Project: IEEE P802.15 Study Group for Wireless Personal Area Networks (WPANs)

Submission Title:	PSSS proposal – Parallel reuse of 2.4 GHz PHY for the sub-1-GHz bands								
Date Submitted:	15th April 2005								
Source:	Andreas Wolf, DWA Wireless GmbH and Hans van Leeuwen, Integration								
	DWA Wireless GmbH, Germany Tel.: +49 (0)700 965 32 637 aw@dw-a.com								
	Integration, USATel: +1 858 344 5120hvl@highstream.net								
Re:	PSSS mode for more even chiprates, simpler filter, and 250 kbit/s in 868 MHz and new less complex preamble.								
Abstract:	Ballot comments received indicated interest in the TG4b task group to modify the PSSS mode for 868 MHz to have the same 250 kbit/s bitrate as the 2.4 GHz and the PSSS 915 Mhz modes. Offering also simpler preamble.								
Purpose:	Response to ballot comments to discuss potential modifiation of PSSS draft specification								
Notice:	This document has been prepared to assist the IEEE P802.15. It is offered as a basis for discussion and is not binding on the contributing individual(s) or organization(s). The material in this document is subject to change in form and content after further study. The contributor(s) reserve(s) th

PSSS 250-400 868 MHz Coding Table:

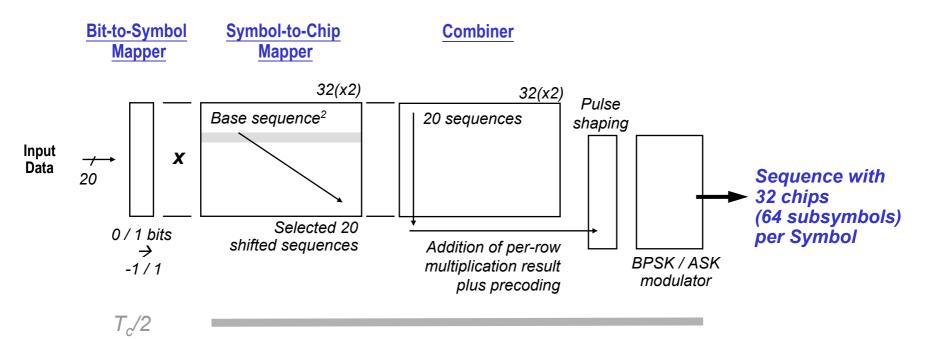
Shifting of sequences by 3 instead of 4 subchips enables addition of sequences to achieve 250 kbit/s and 400 kcps

• 2 sub-chips per chip – basic chip rate of coding scheme is unchanged

• Addition per sub-chip for multivalue encoding – no other changes of PSSS model

Comparision Actual/New Proposed Preamble Length of Proposed Preamble

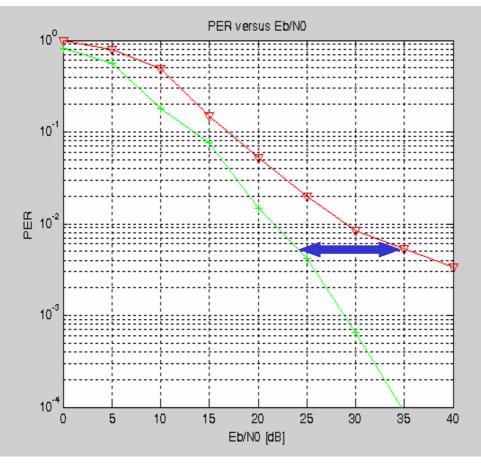
• The Sequence 0 is repeated 8 times for having similar definition like for i.e. 2.4 GHz Phy.

PER Performance PSSS 250-400 868 MHz (BPSK/ASK) – Discrete Exponential Channel, 250ns RMS Delay Spread

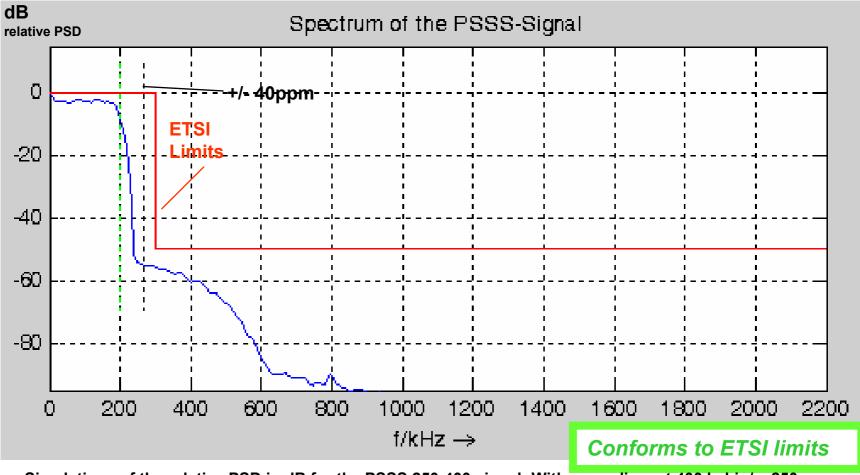
• No visible degradation of performance

PSD for PSSS 250-400 868 MHz (in 600 KHz channel) Baseband pulse shaping non-linear "Real World PA"

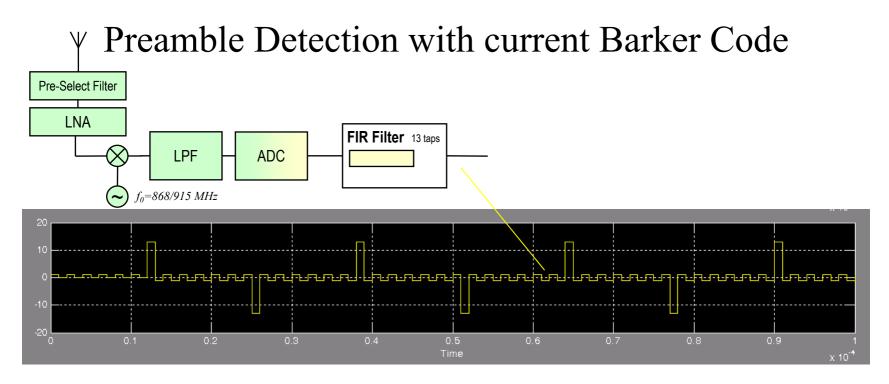
Simulations of the relative PSD in dB for the PSSS 250-400 signal: With precoding, at 400 kchip/s, 250 kbit/s, +/- 40ppm, 50% PA drive, square root raised cosine filter with r = 0.2

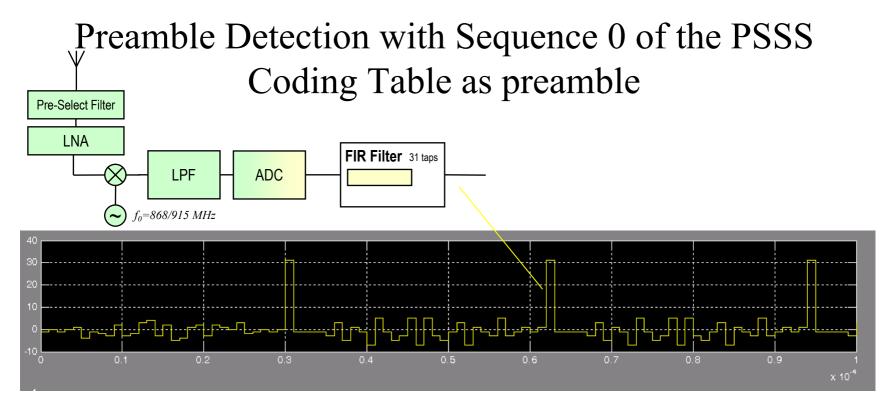
- When detecting the current barker code based preamble with FIR filter, the signal coming out of the FIR filter has side slopes limited to +/- 1.
- Advantages:
 - DC free
- Disadvantages:
 - Two FIR filters needed, one for preamble detection (13 chip barker code), one for PSSS decoding (31 chip m-sequence).
 - Not multiple of symbol duration

- When detecting the preamble, base on repeated sequence 0 with FIR filter, the signal coming out of the FIR filter has side slopes limited to +5/-6.
- Advantages:
 - Use of just one FIR filter or correlator for preamble detection and PSSS decoding.
 - 32 chip long preamble code.= multiple of symbol duration and similar to other phys.
 - DC free
